C-900 - ADDENDUM

Addendum No. 3

Date:	<u>March 29, 2019</u>
Issued To:	<u>Plan Holders</u>
From:	<u>Alan Plummer Associates</u>
Project:	<u>Wastewater Treatment Plant Expansion</u>

OVERALL SITE PLAN

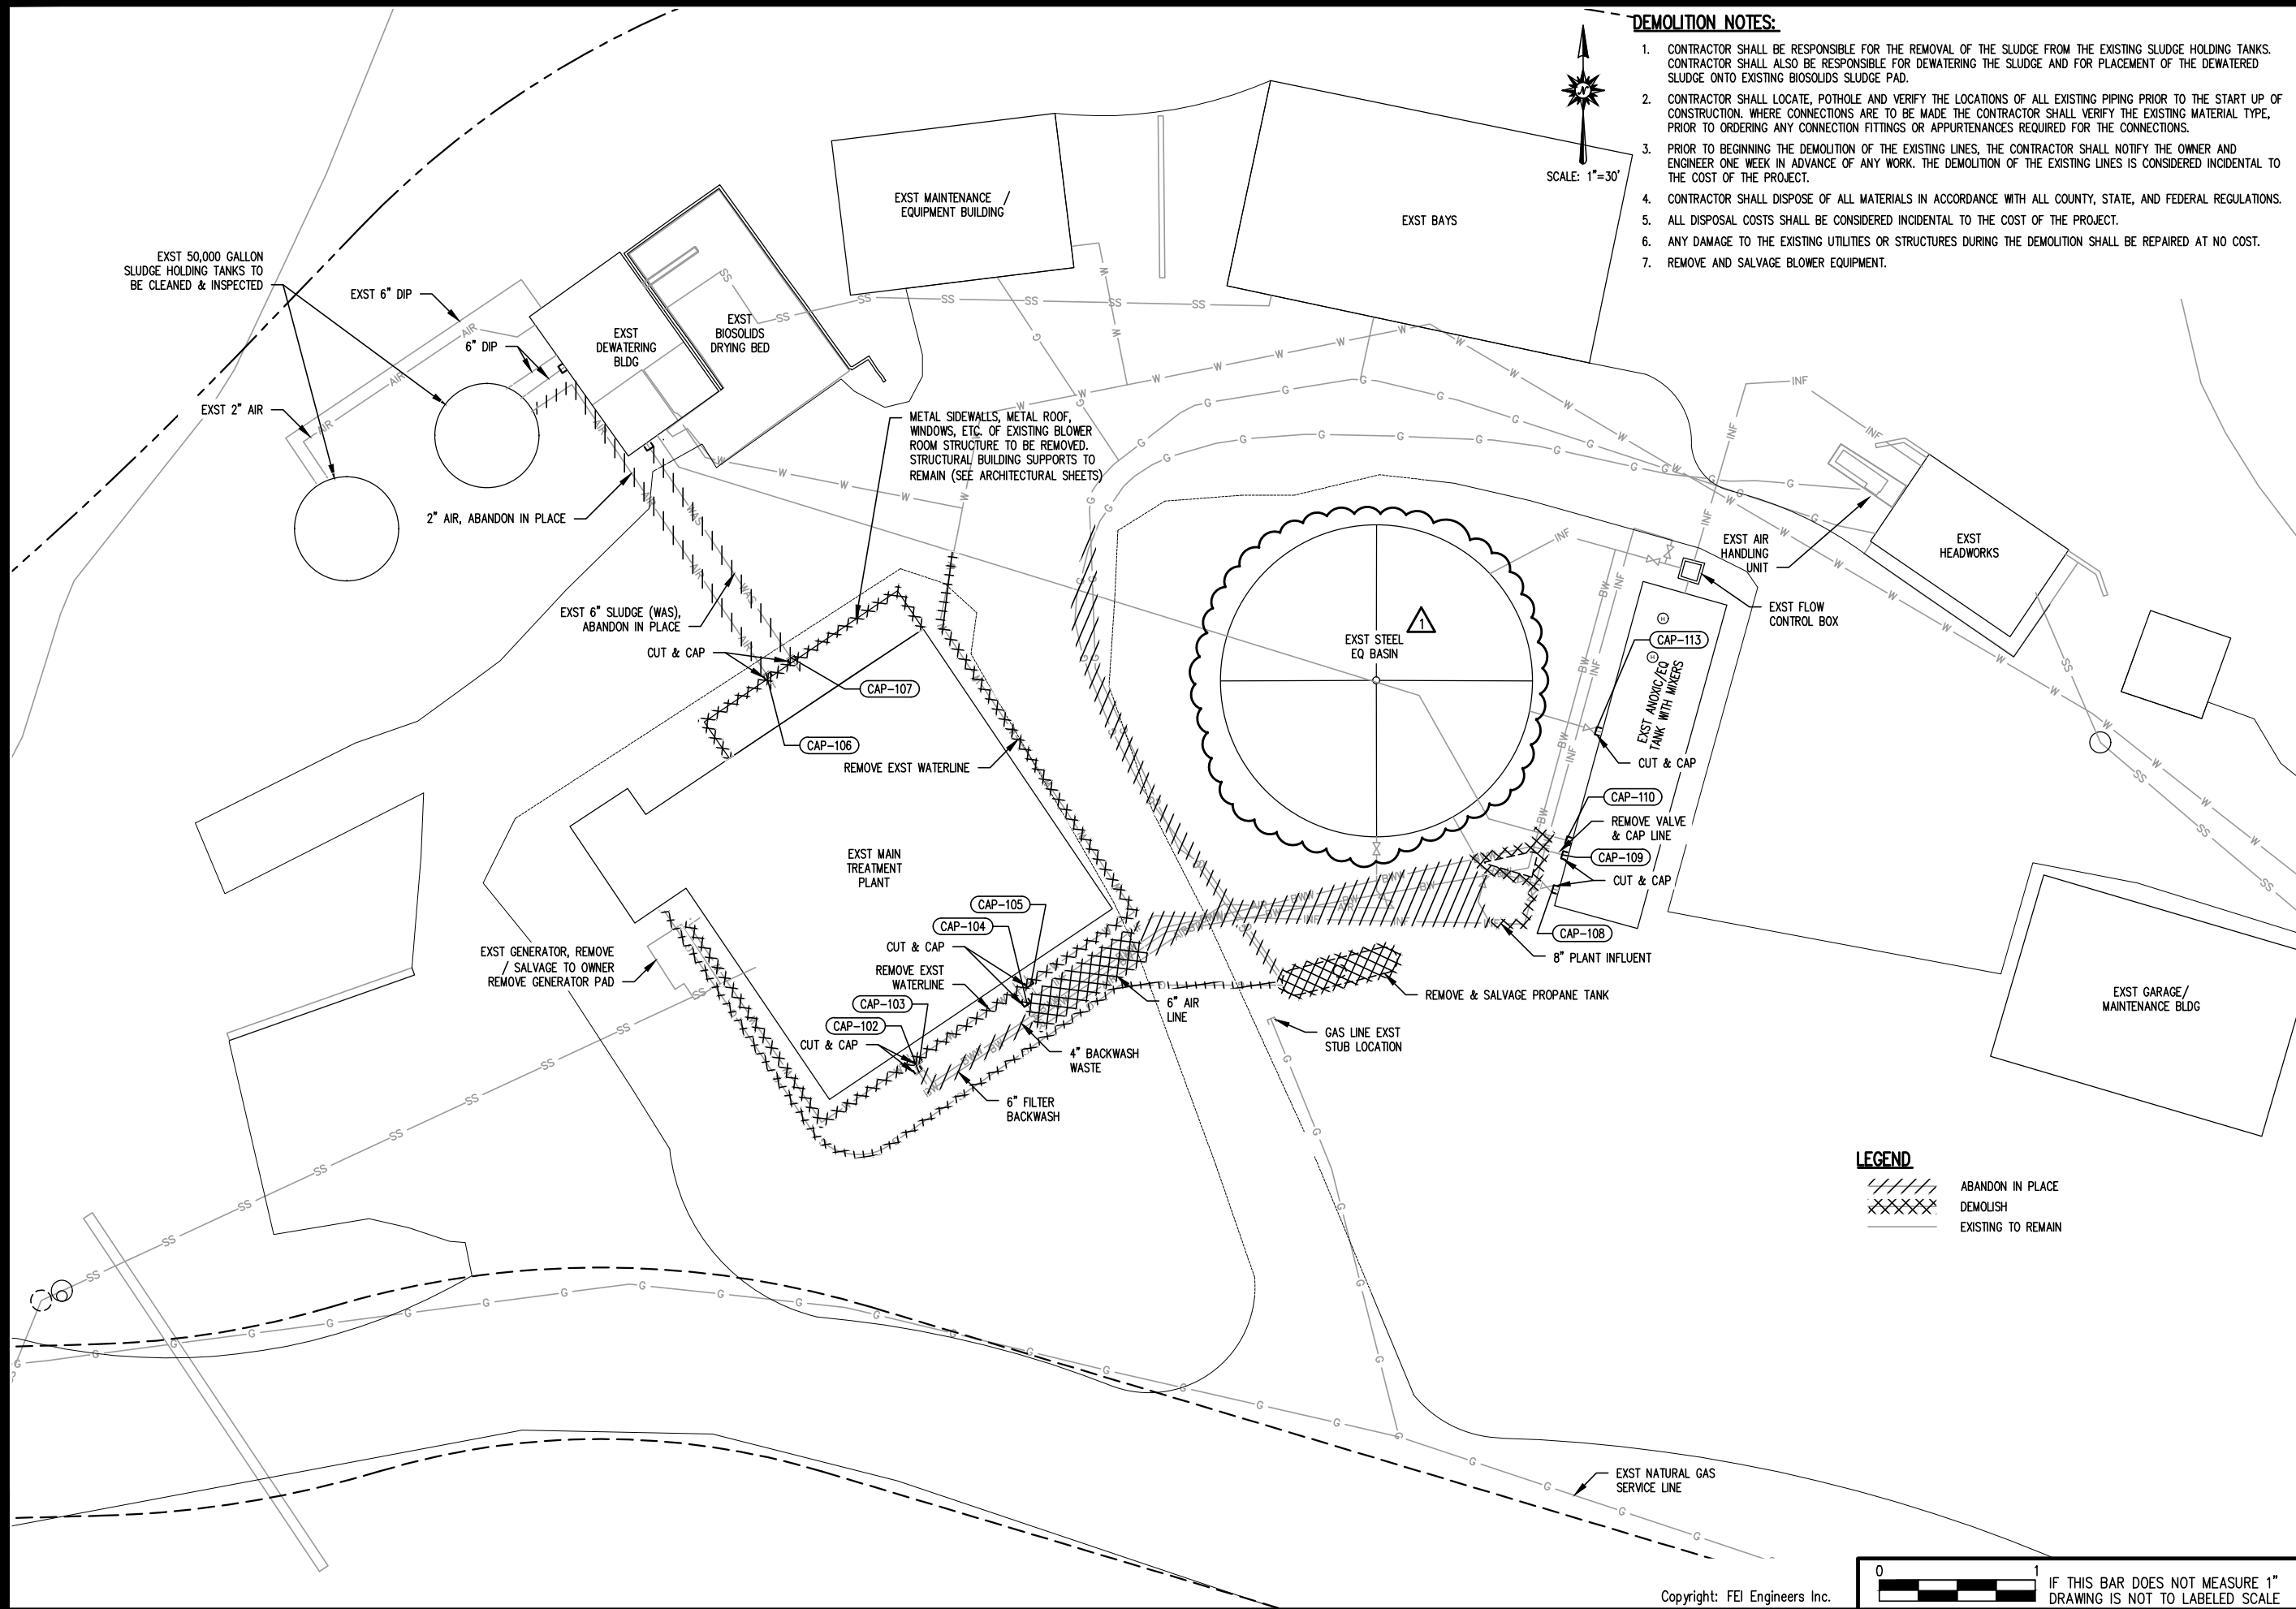
1. Response: Waterstop is not required in either the retaining wall or in the walls for the new building.
- X. On Sheets C1 – 01, 02, 03 and 06, it calls out to demo the existing underground tank. In order for this to be done, we need to know:

1. How deep the tank is?
 - a. Response: The existing underground tank is to remain. Refer to revised Civil Sheets in this Addendum.
 2. Is there any material in it: liquid or solid? How much material?

EXISTING YARD PIPING &
DEMOLITION PLAN

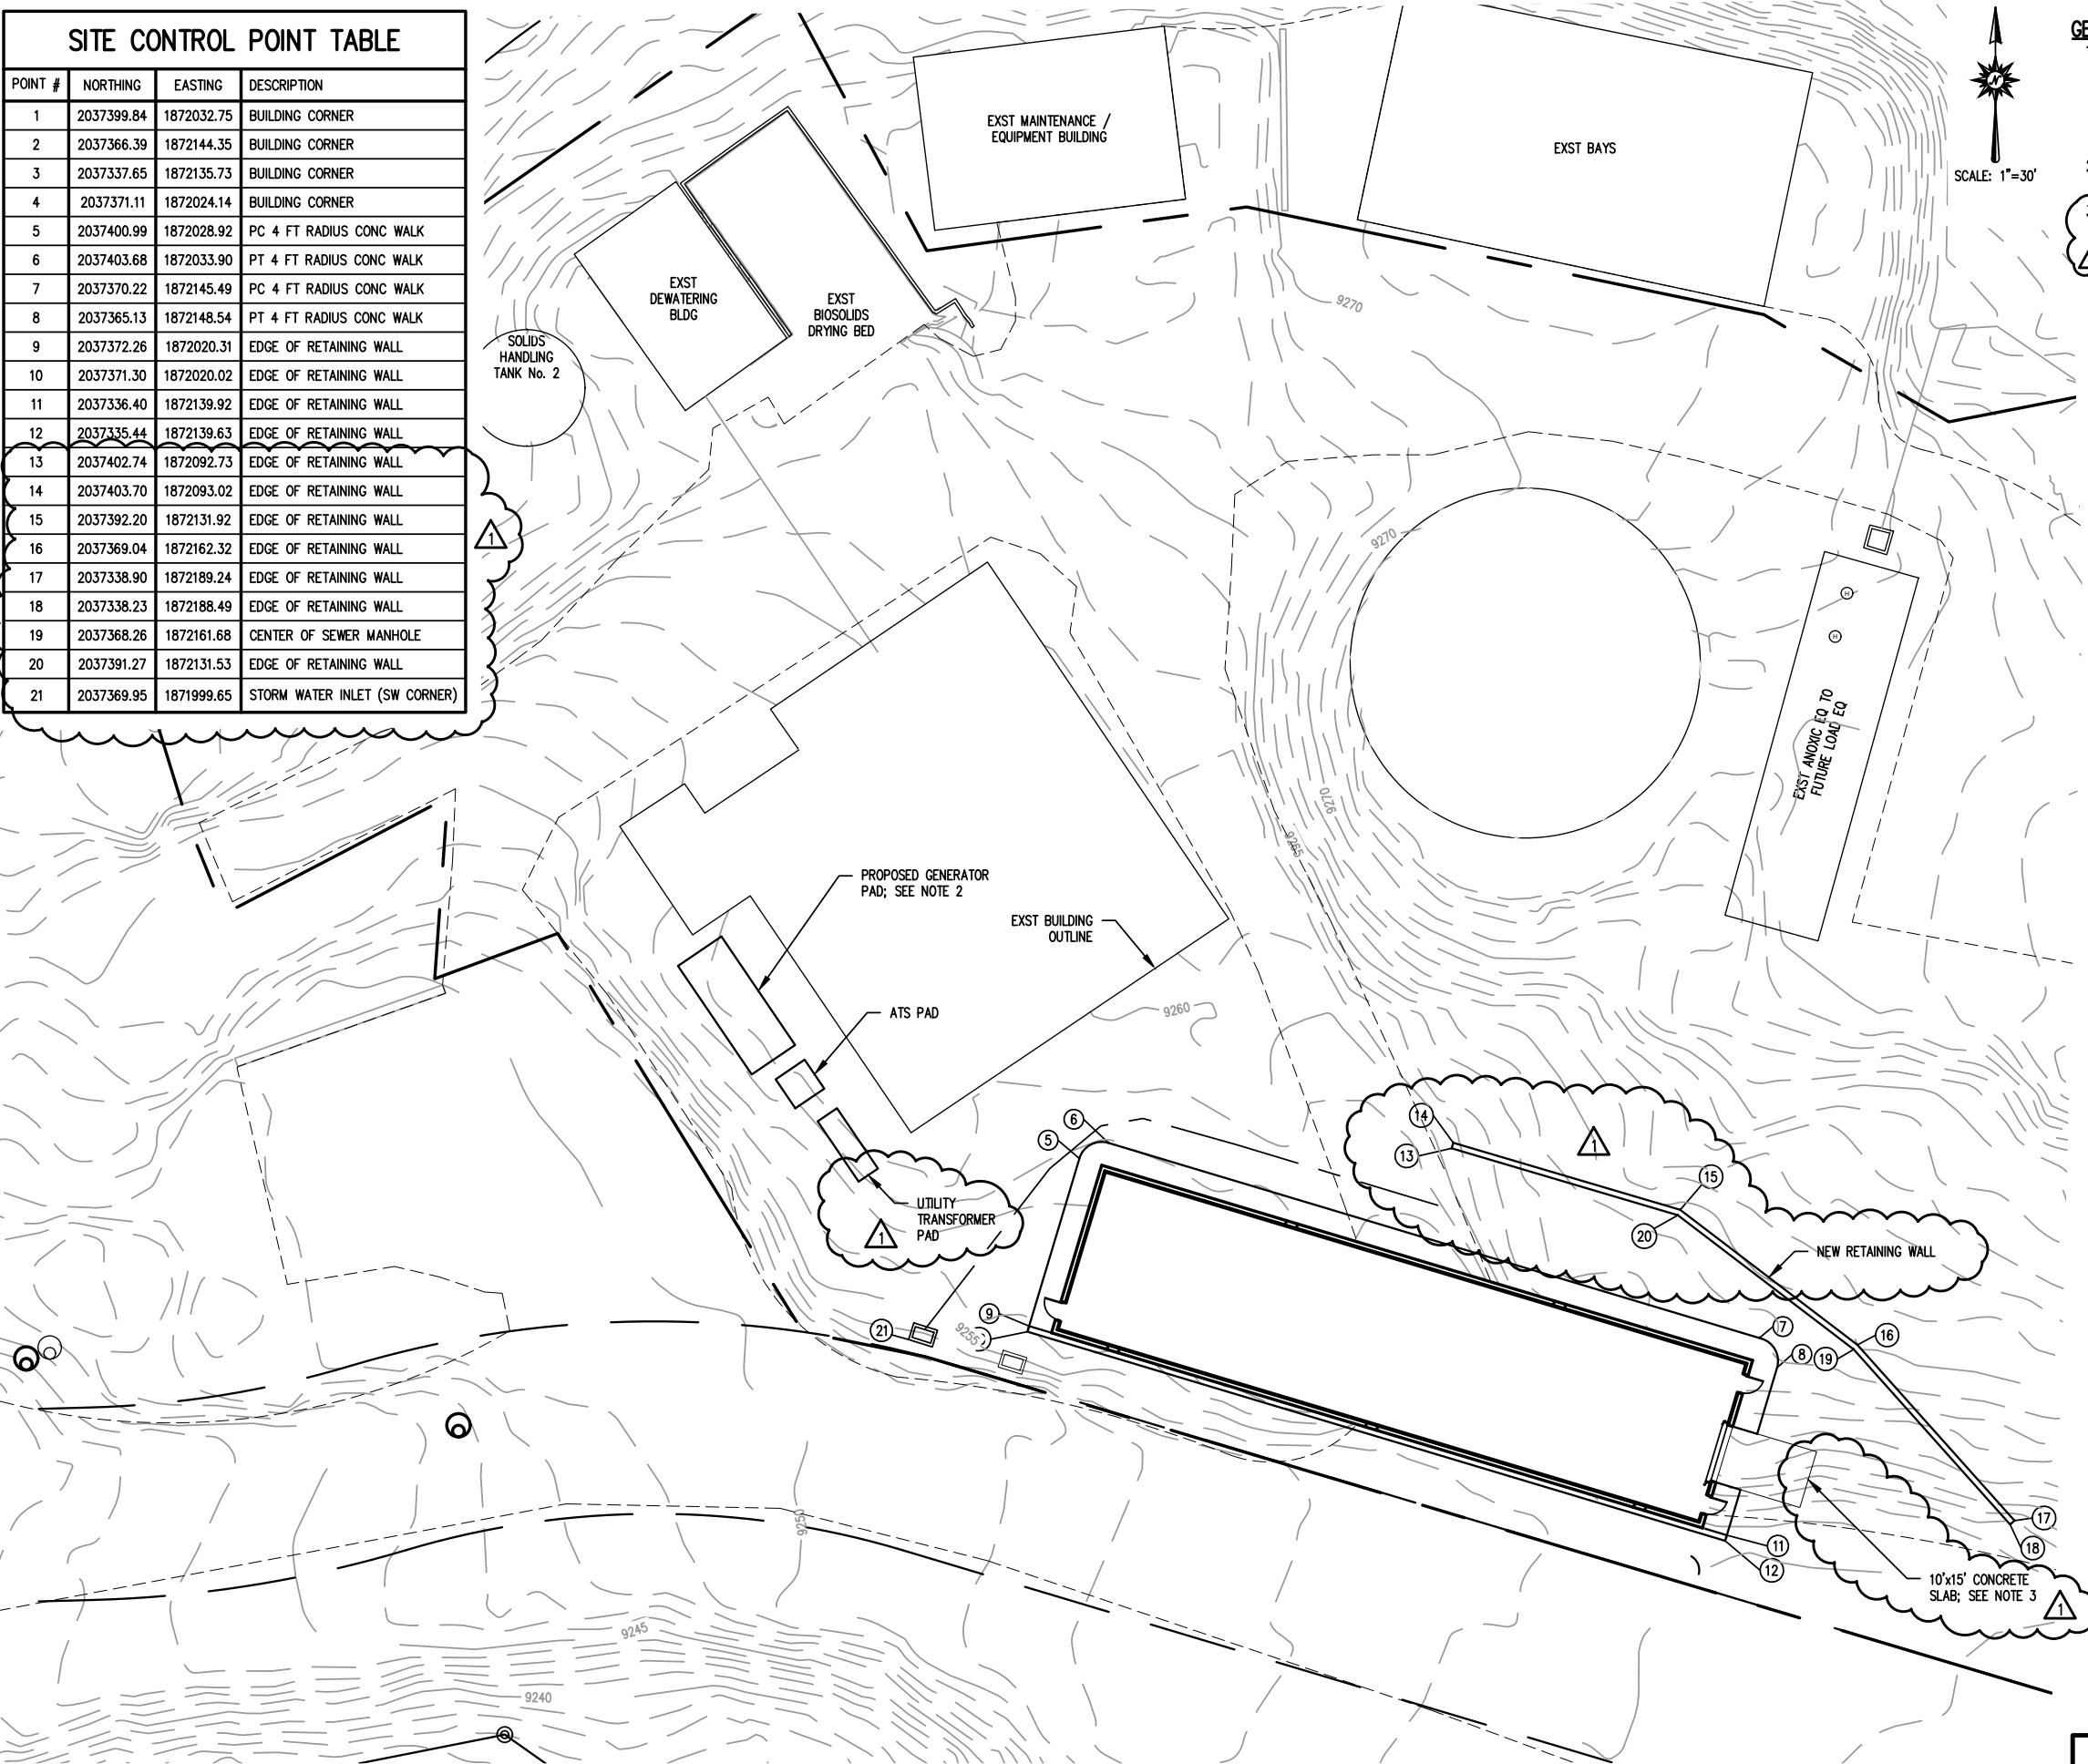
- a. Response: The existing underground tank is to remain. Refer to revised Civil Sheets in this Addendum.
- 3. What should be done with the giant hole in the ground once the demo is complete; leave the hole or it backfill it? (We need finish design contours for the final grading of the excavation.)

- a. Response: The existing underground tank is to remain. Refer to revised Civil Sheets in this Addendum.
- Y. Please indicate the wall heights of the breakroom and restroom, office and chem storage areas.
